1984 Corvette: Service Bulletin: Engine Stops Running When Starting with Air Conditioning "On"

Source: Chevrolet Dealer Service Bulletin

Bulletin No: 84-240

A/C CLUTCH ON REVISED ECM SIGNAL INPUT BLOCK DIAGRAM

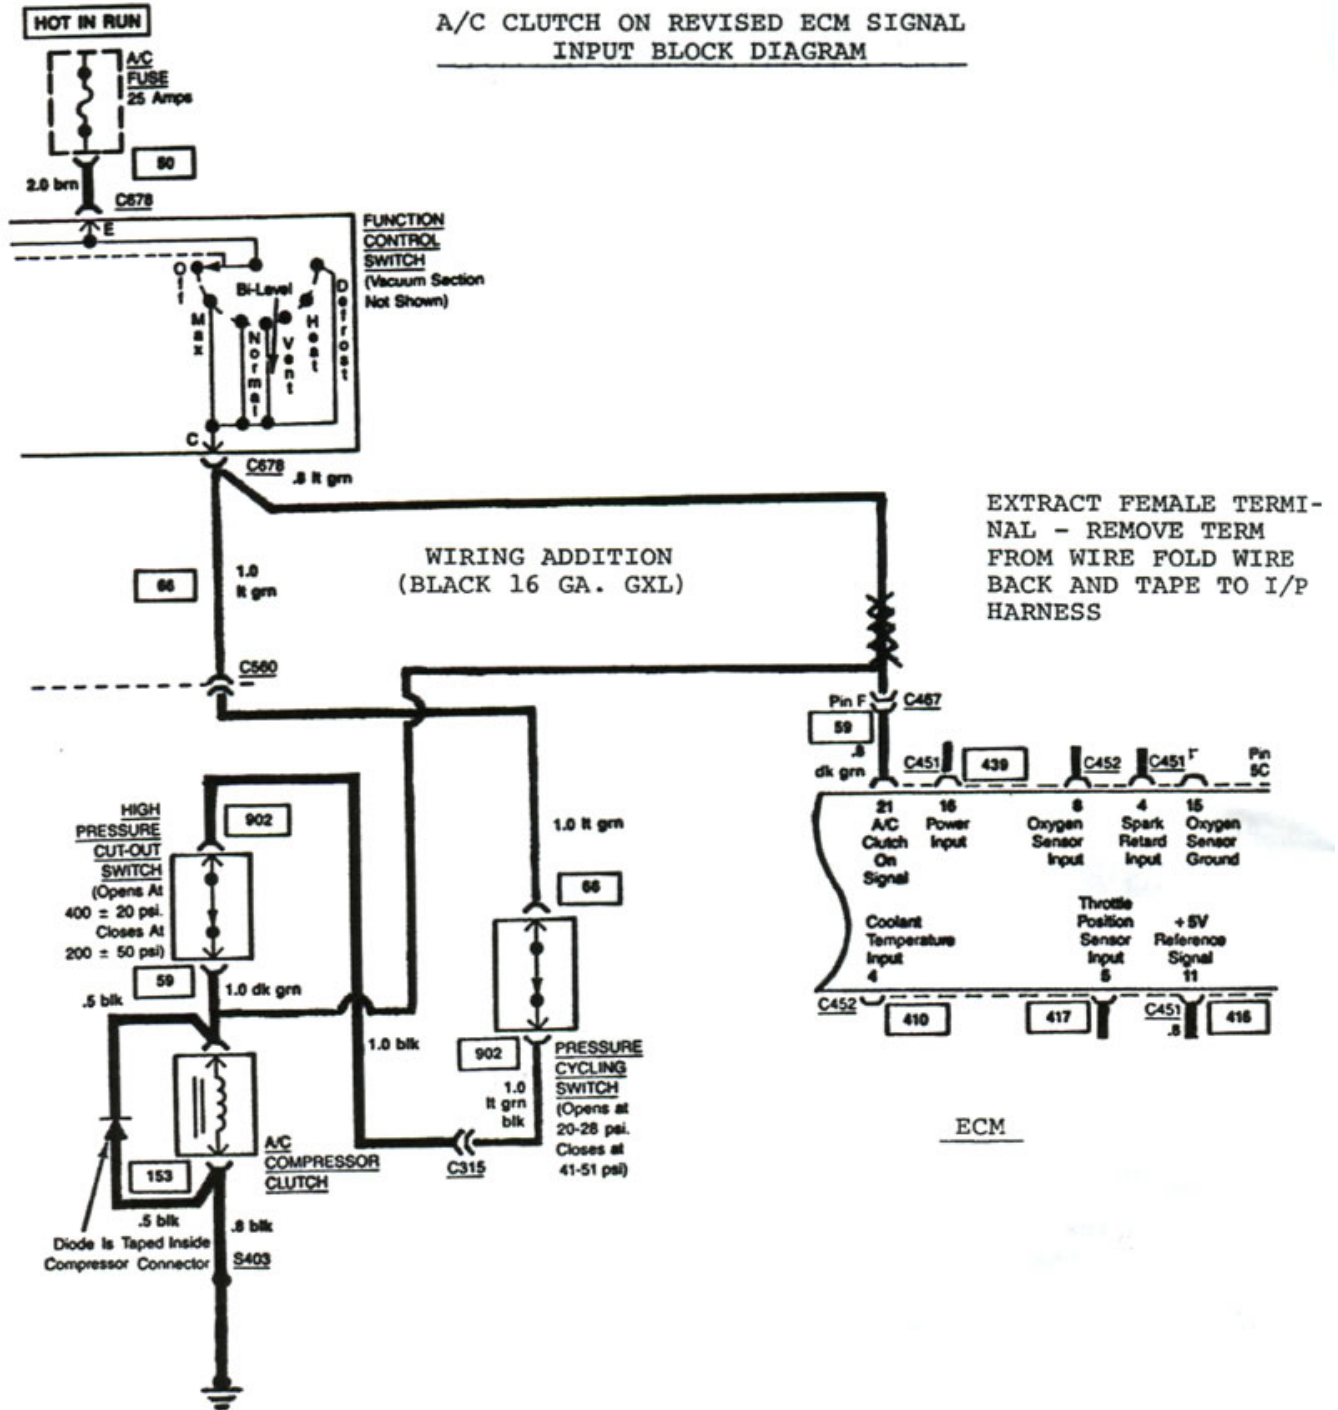
This revision requires installing a 16 Ga. wire into the A/C discrete circuit at connector C-467, Pin F of the I/P to ECM harness, routing the wire through the bulk head connector and splicing into the A/C circuit of the engine, between the pressure cycling switch and the compressor clutch (see block diagram).

FIGURE 1

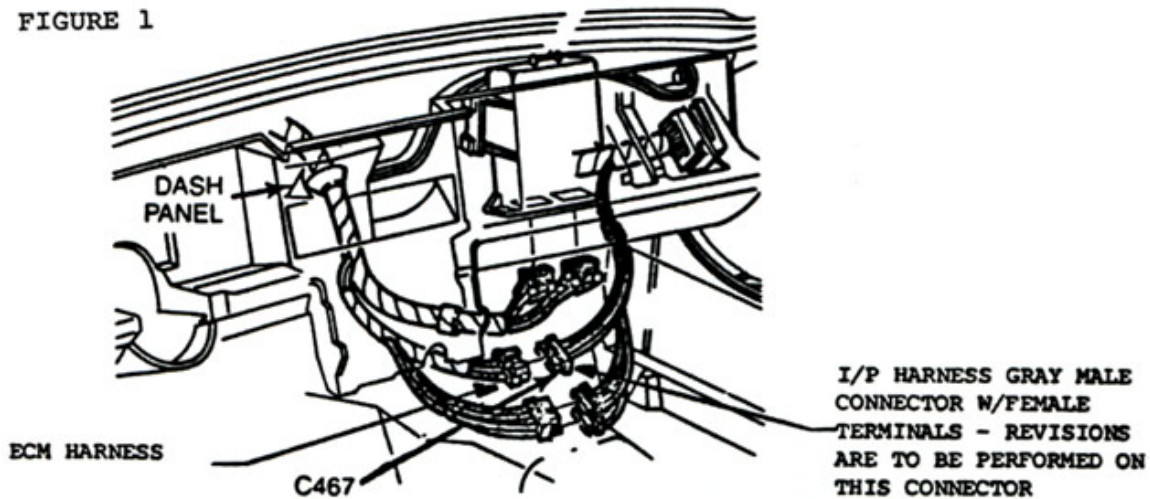
1. Remove I/P upper trim pad assembly. Remove L.H. and R.H. hush panels.
2. Extract female terminal (green wire) from gray I/P to ECM harness connector C-467, circuit 66 (see Figure 1.)
3. Cut off and discard extracted female terminal. Fold severed green wire back and tape it to the I/P harness, making sure the severed wire end is well insulated with electrical tape.
4. Utilize the 22 feet of 16 Ga. GXL black wire by stripping one end and crimping, P/N 12015856, female terminal on the stripped end. Insert the new terminal into connector C-467, Pin F.

FIGURE 3

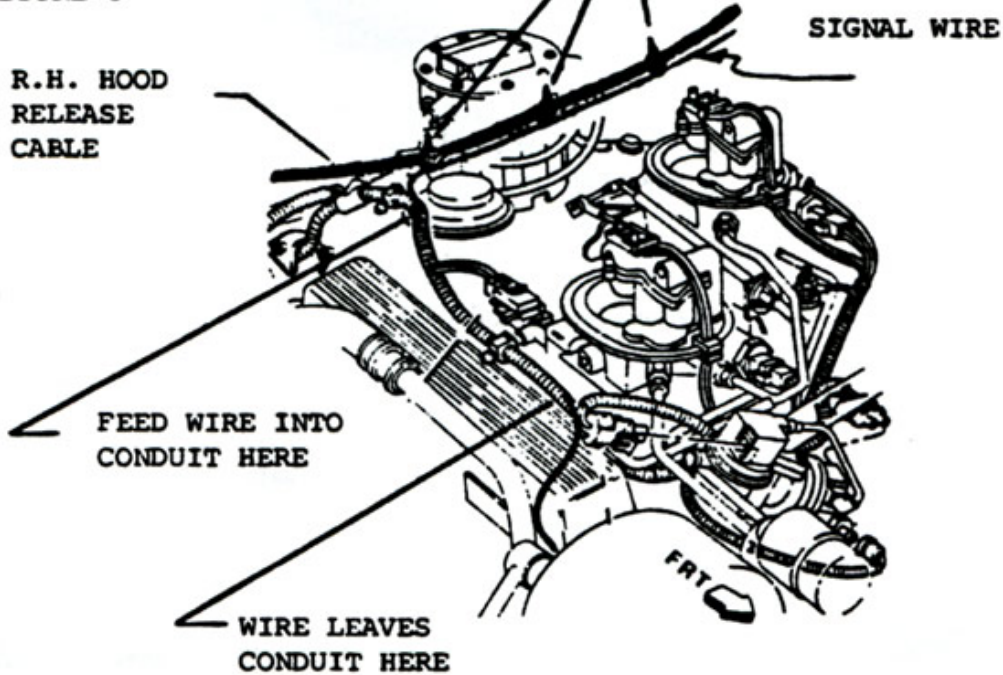
9. Once the signal wire has been fed through the bulk head connector, grease is to be packed around the signal wire at both sides of the connector. This step assures an adequate bulk head connector to signal wire seal.
10. Reinstall the bulk head harness caps.
11. Loop the signal wire down below the bulk head connector and back up behind the brake booster (see Figure 2.)
12. Route the signal wire along the R.H. hood release cable securing the wire to the cable with three (3) cable ties.
13. At the R.H. rear corner of the engine, direct the wire to the front of the engine and install it in the existing engine harness conduit (see Figure 3.)

FIGURE 4

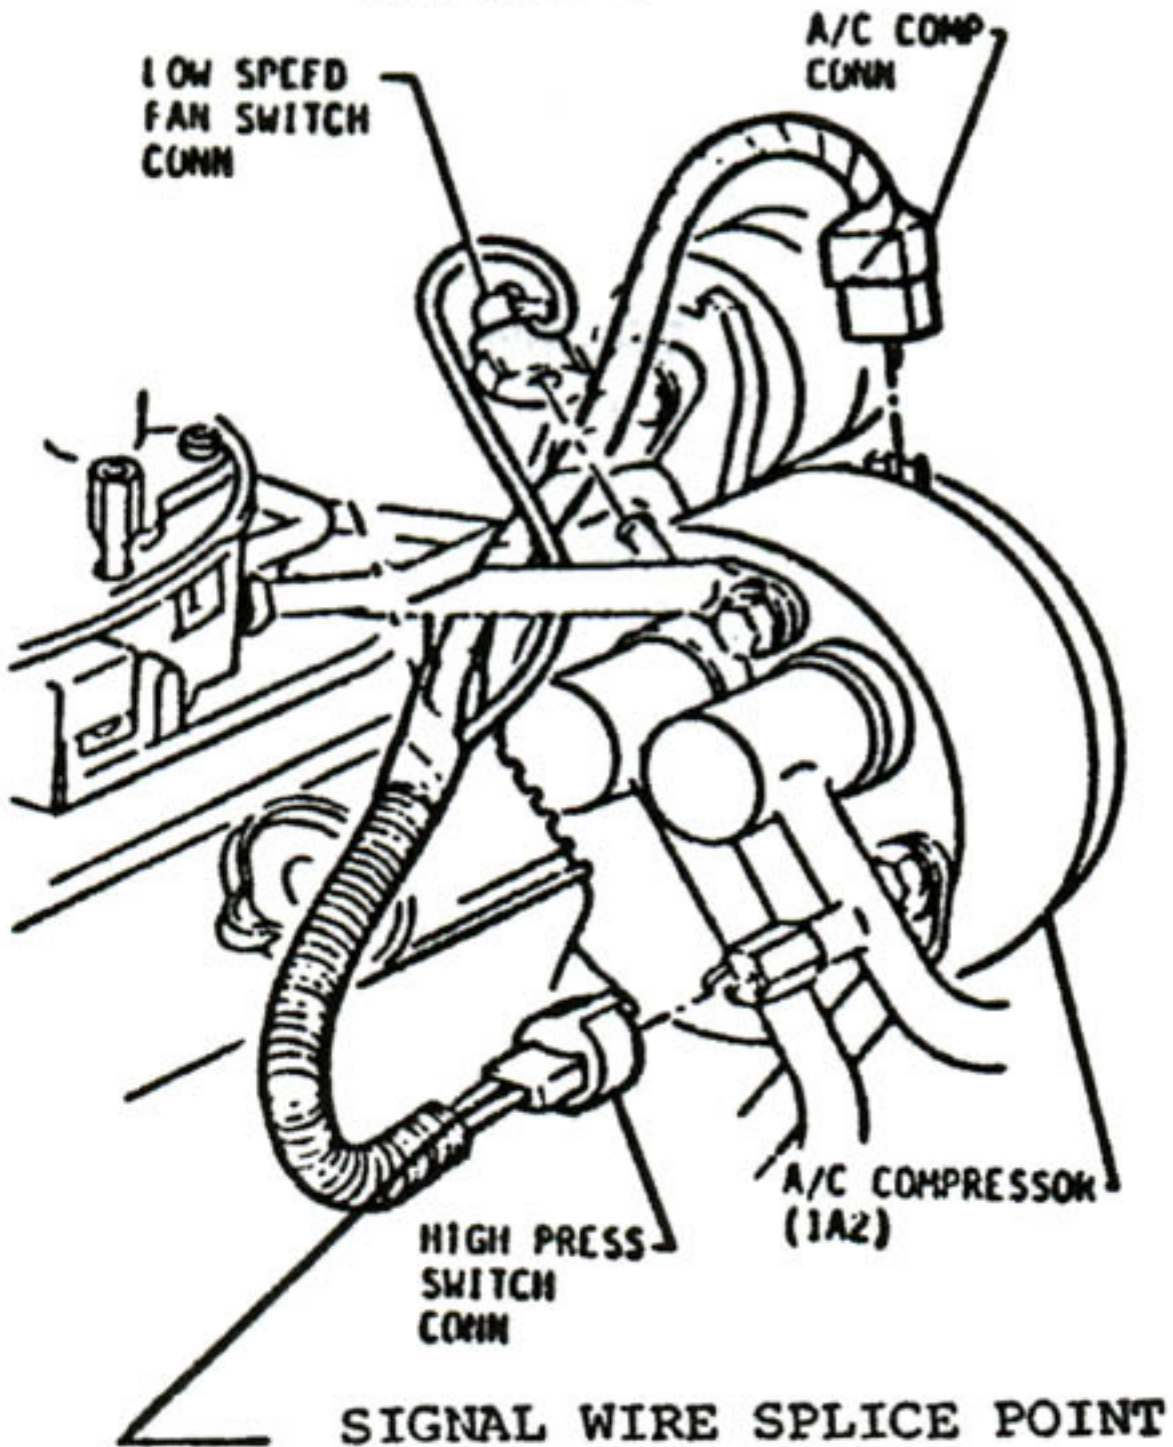
14. Remove the harness end tape and strip the insulation back .5 inches on the green wire at the high pressure A/C switch connector (see Figure 4.)
15. Remove excess signal wire length, if necessary, and strip end back .75 inches. Wrap the signal wire around the A/C clutch green wire and solder to insure a good connection.
16. Retape harness at high pressure switch connector.
17. Reinstall I/P upper trim panel and hush panels.
